Does 1166L
BNSF Need Plans?
~~Hal Industrial~~ Barnett Industrial
BNSF Conflict Sta 16620+00 WL

~~SECRET~~
BNSF Conflict No. 27 & 28

BNSF Conflict No. 37

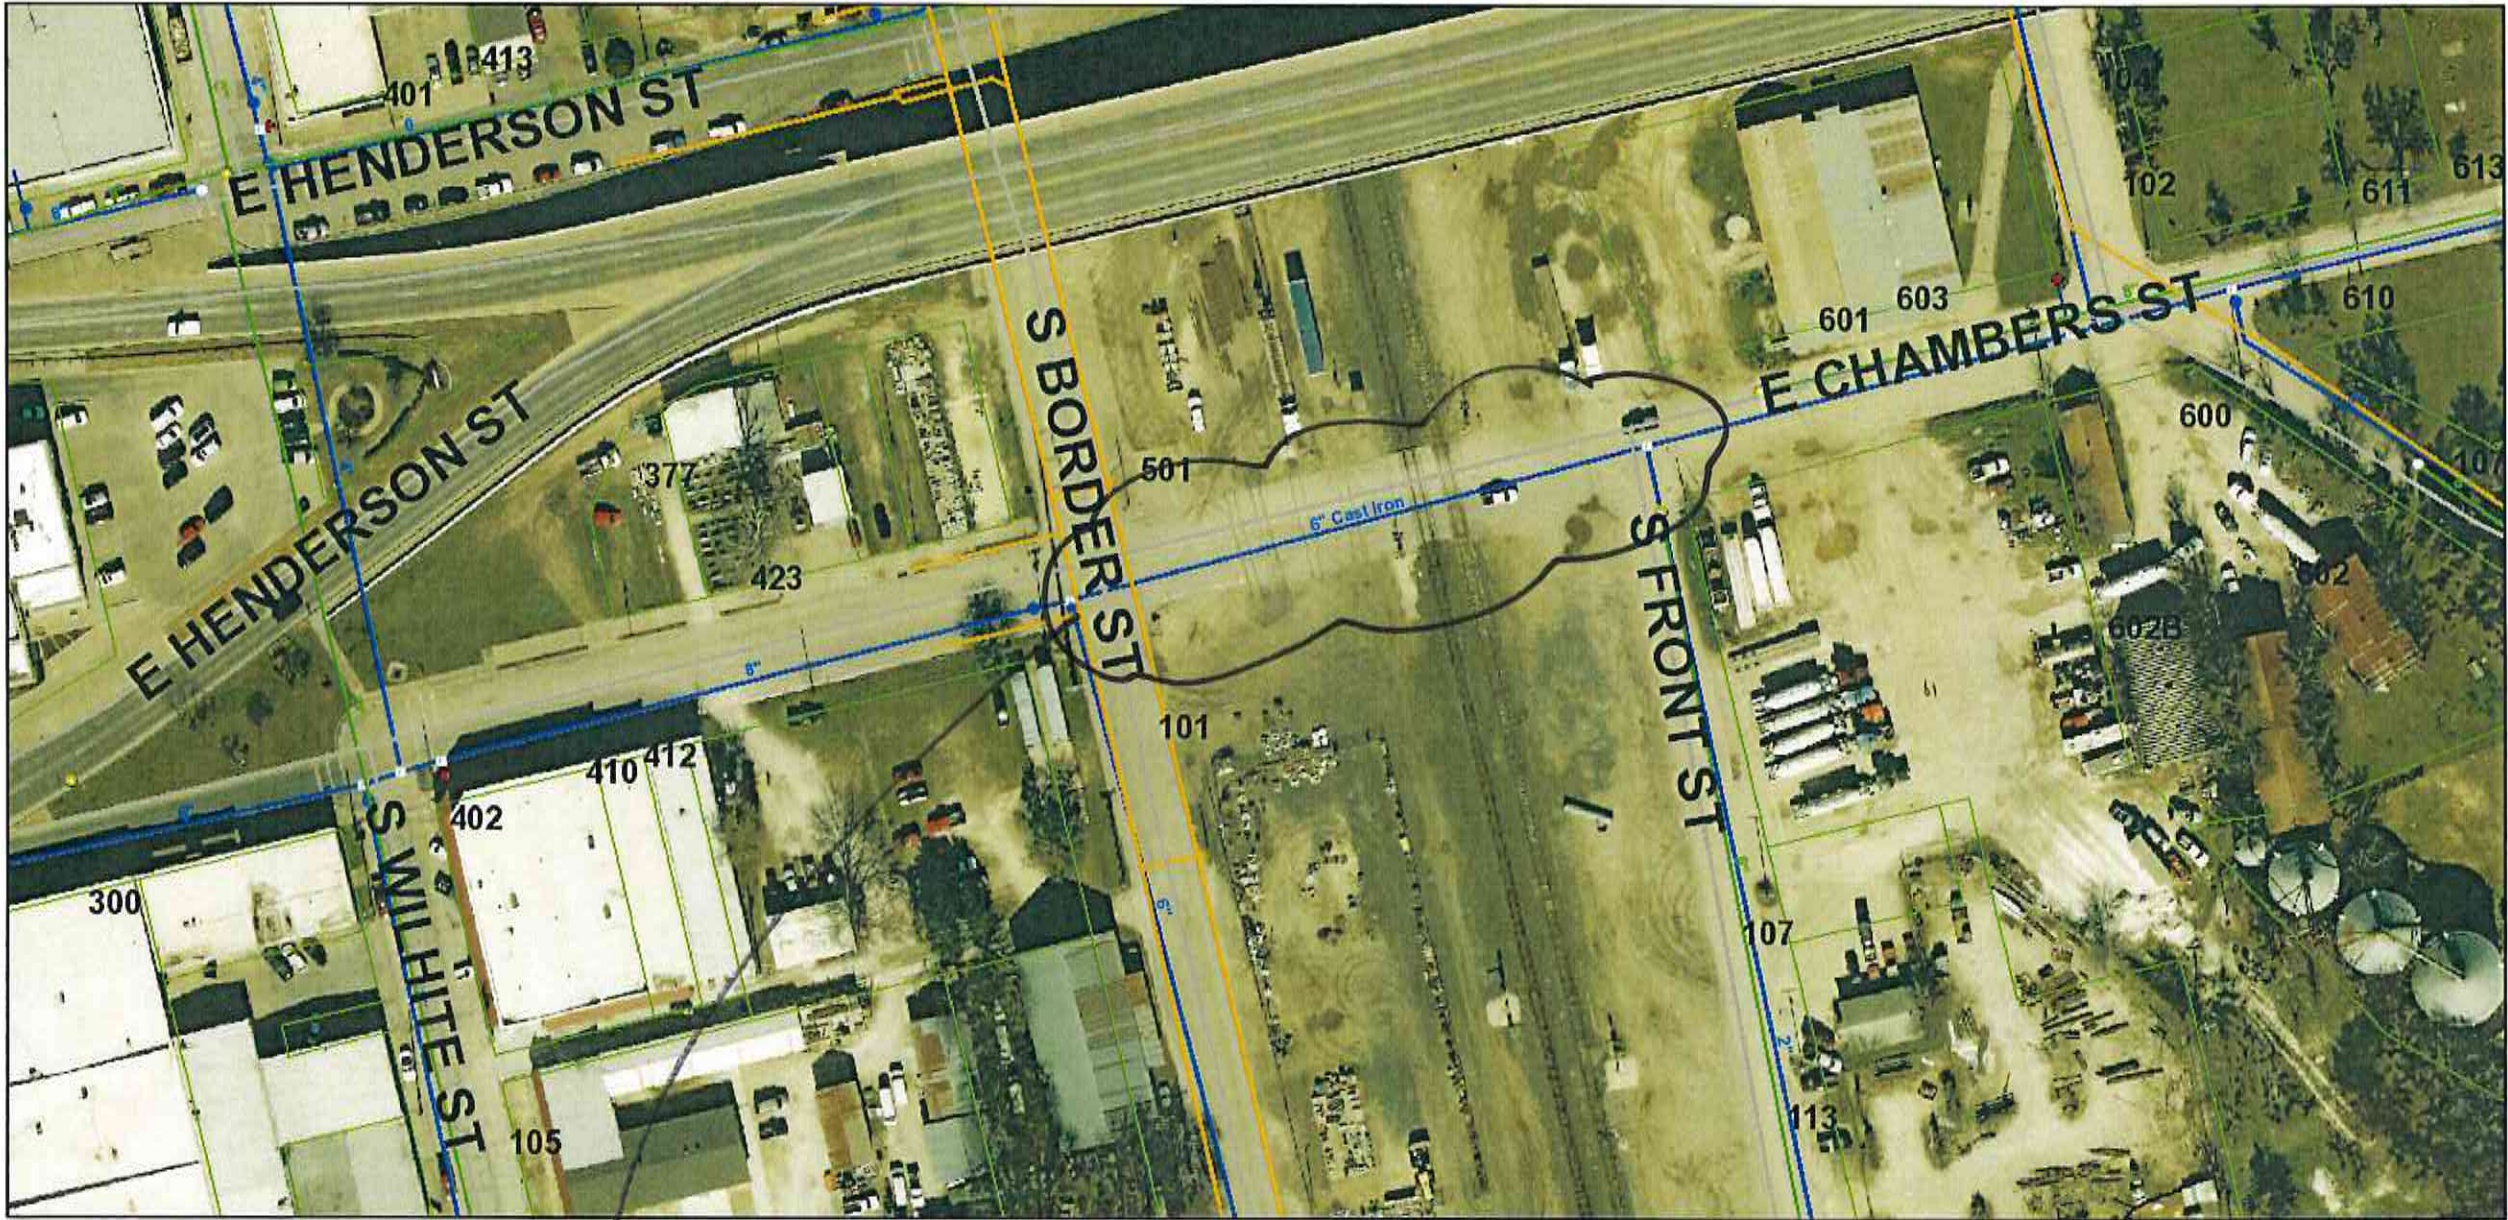
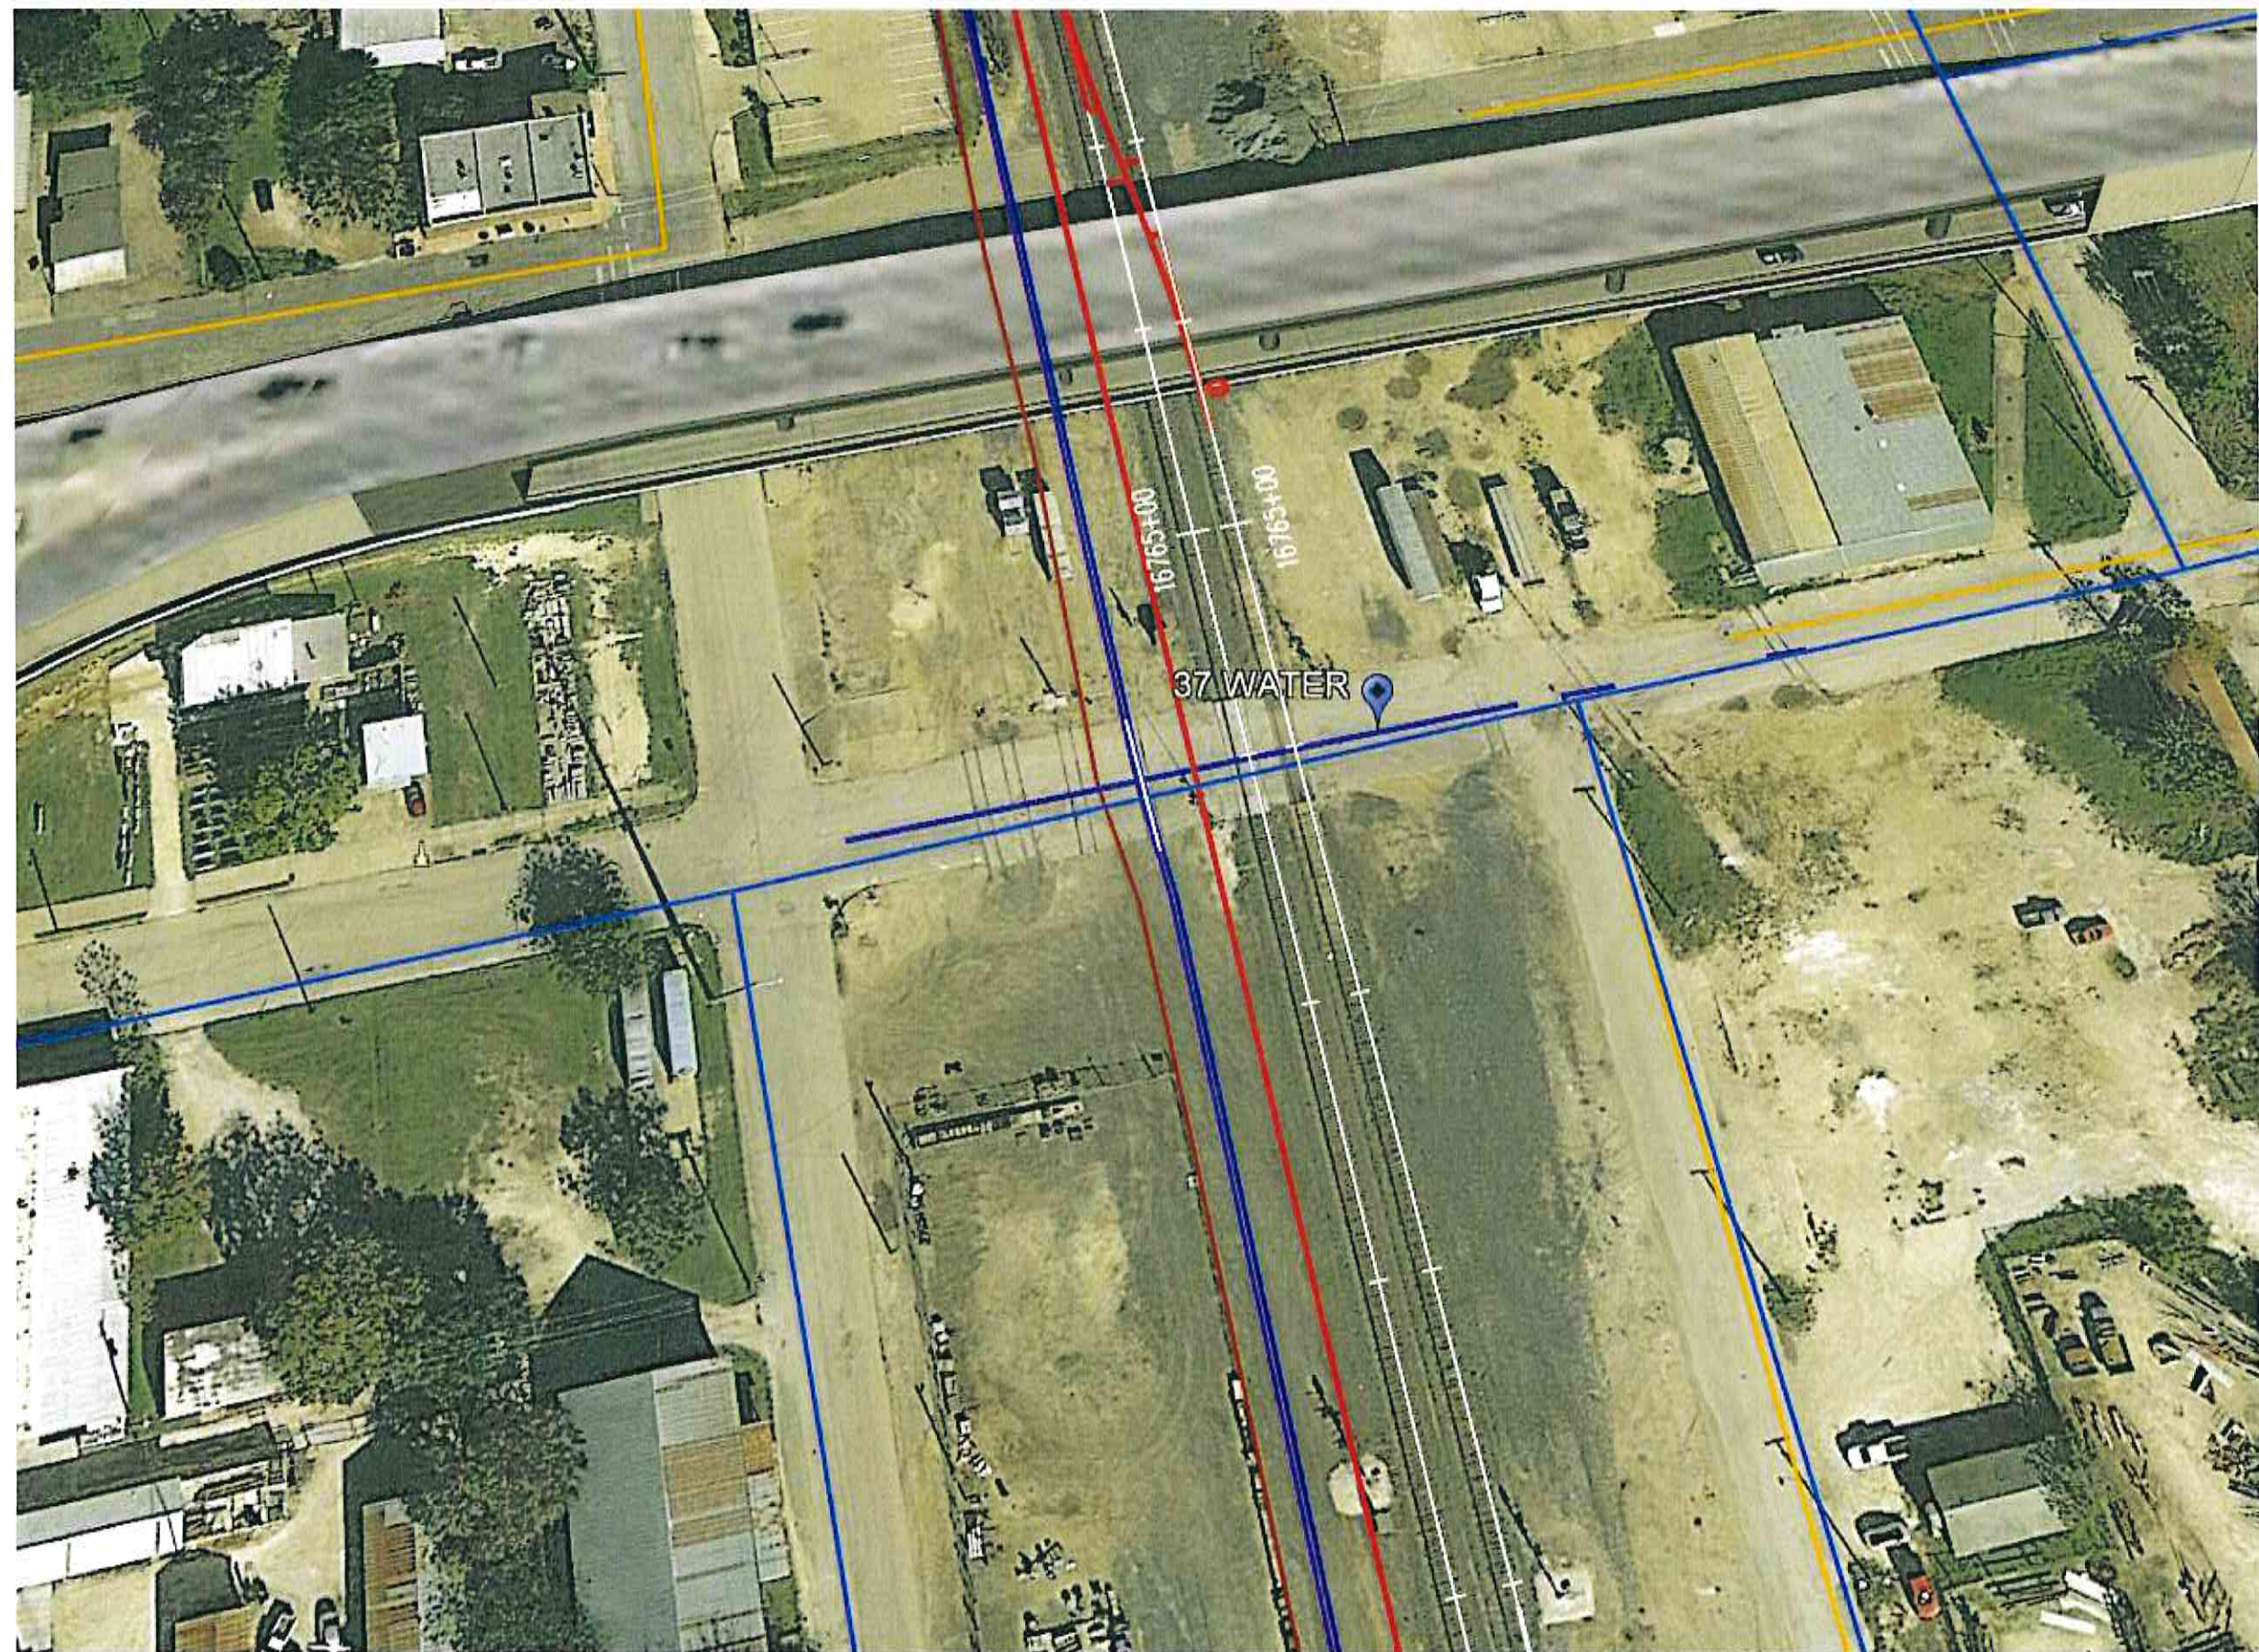
active 6" water line - approx 5' deep
found plans U-26 storm sewer parallel to water line

BNSF Conflict No. 45

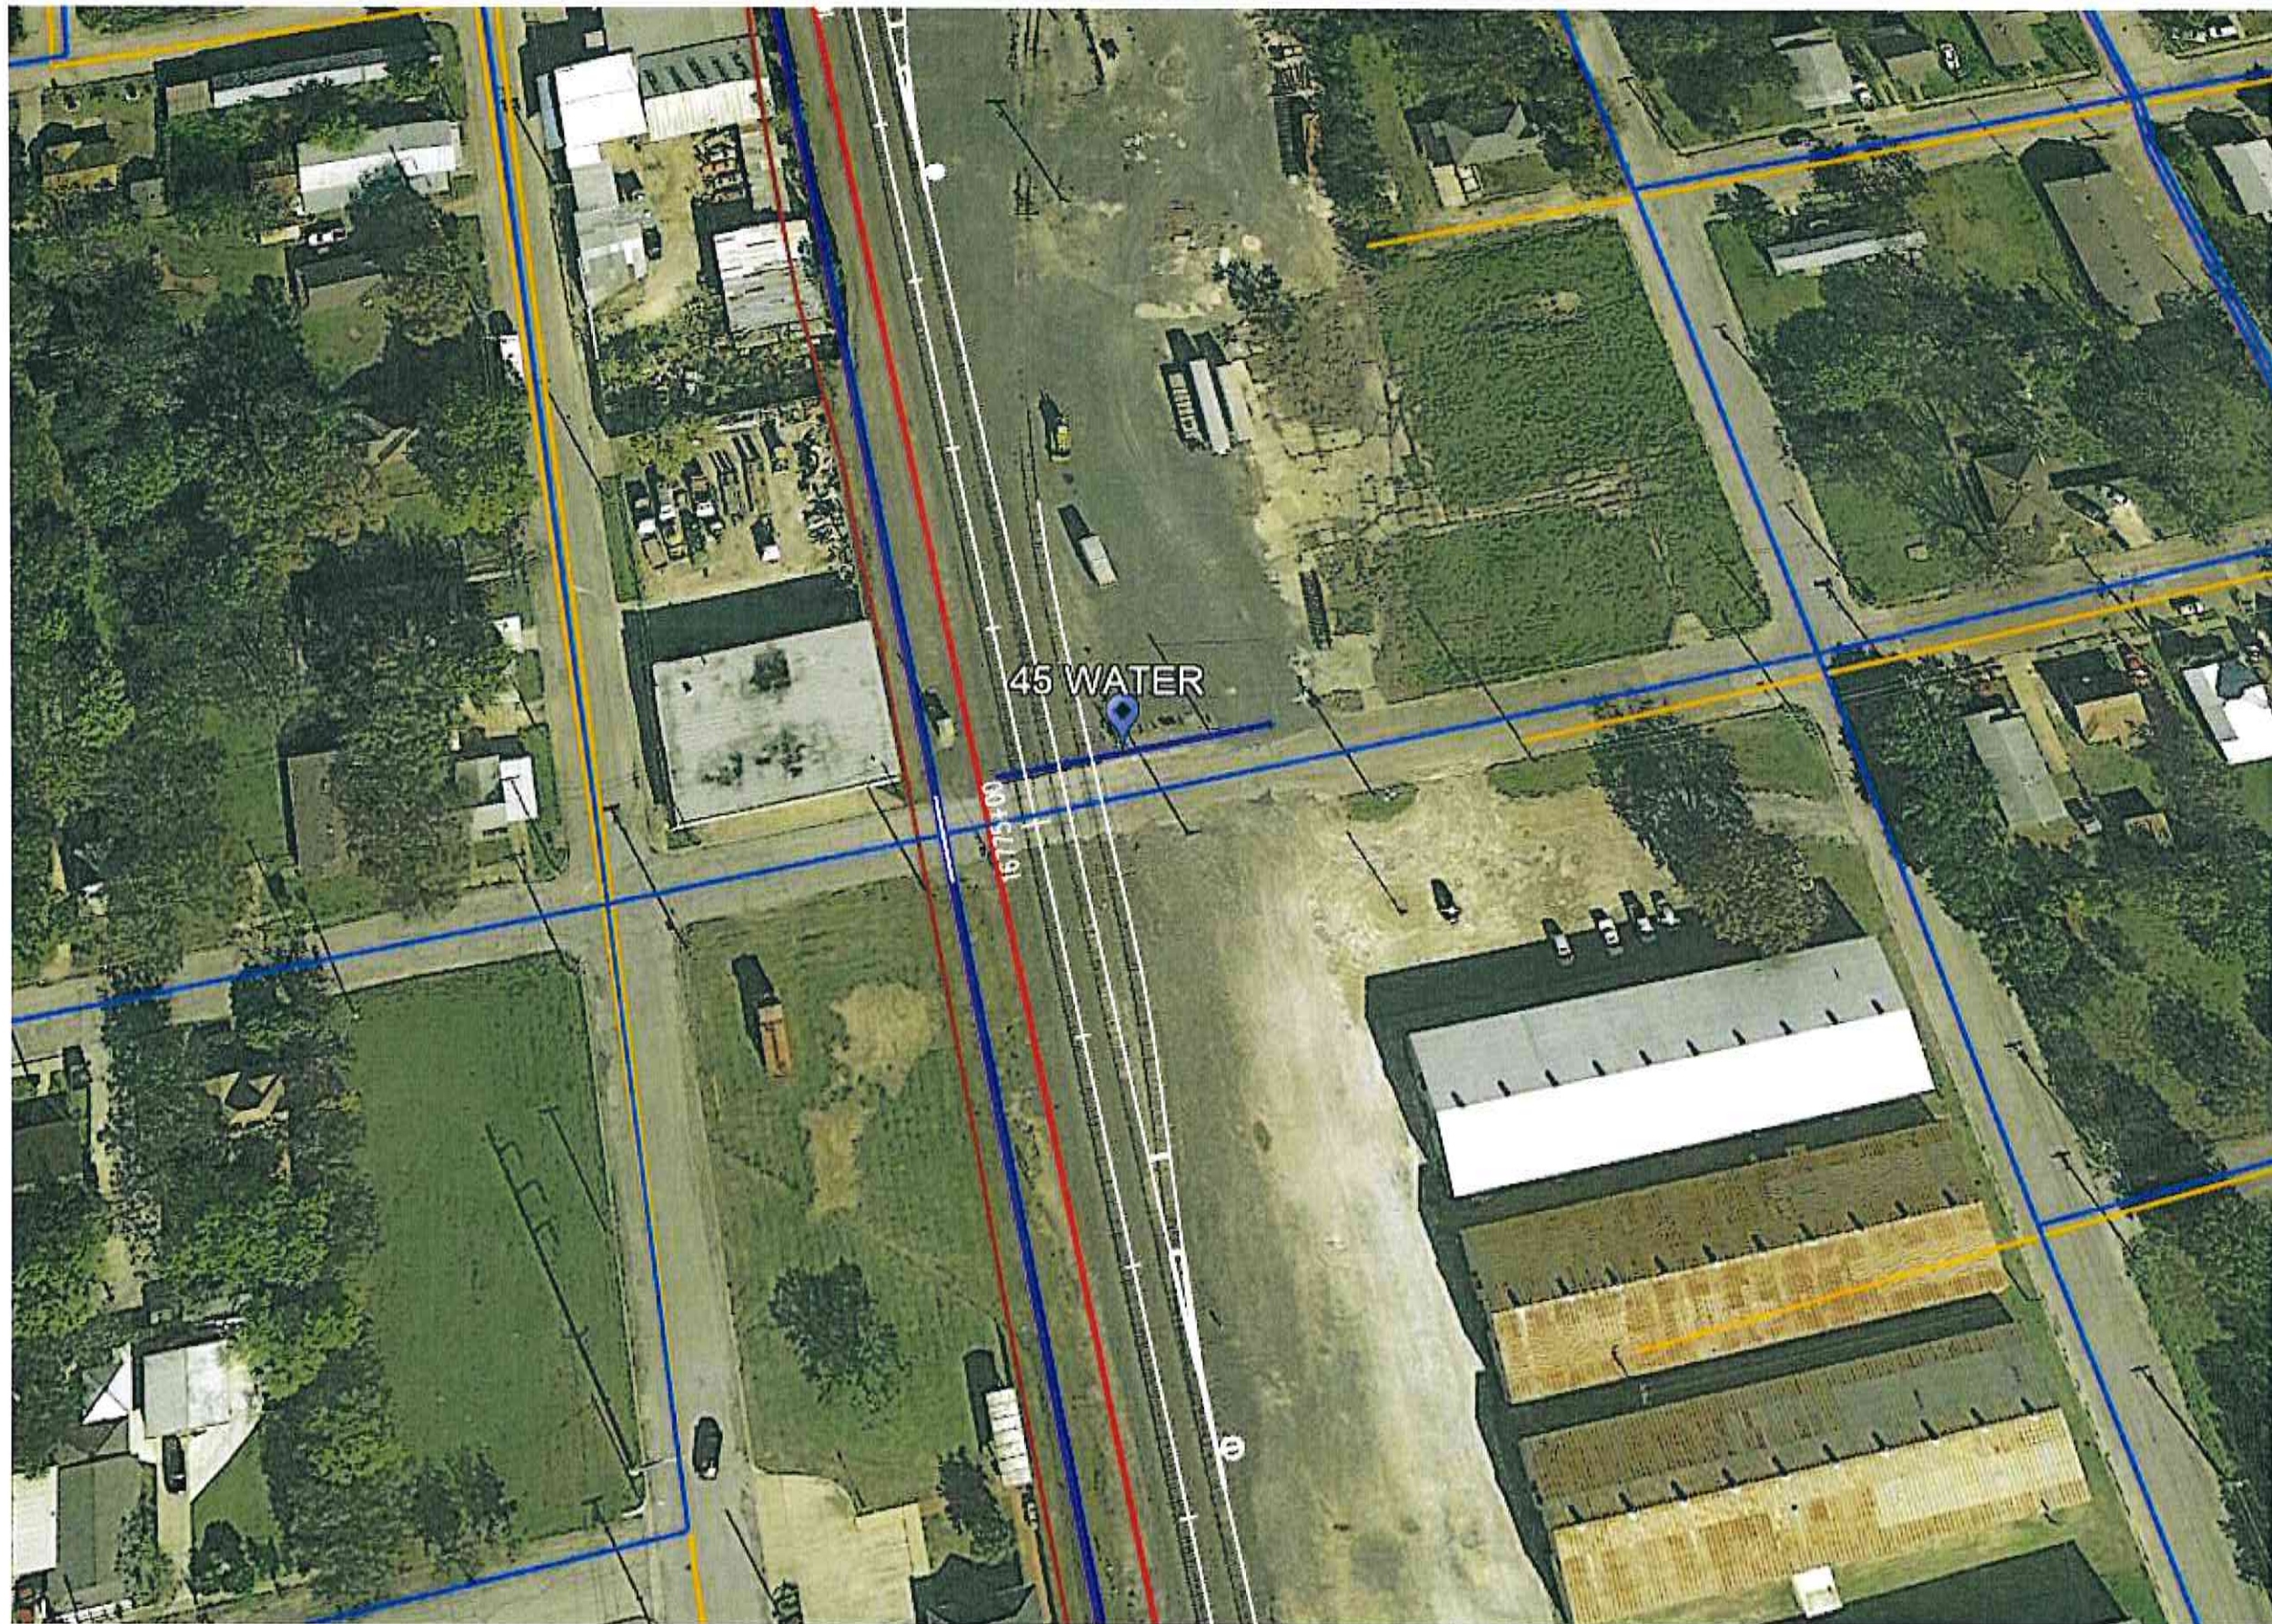
active 6" water line - approx 4' deep
no plans on water line
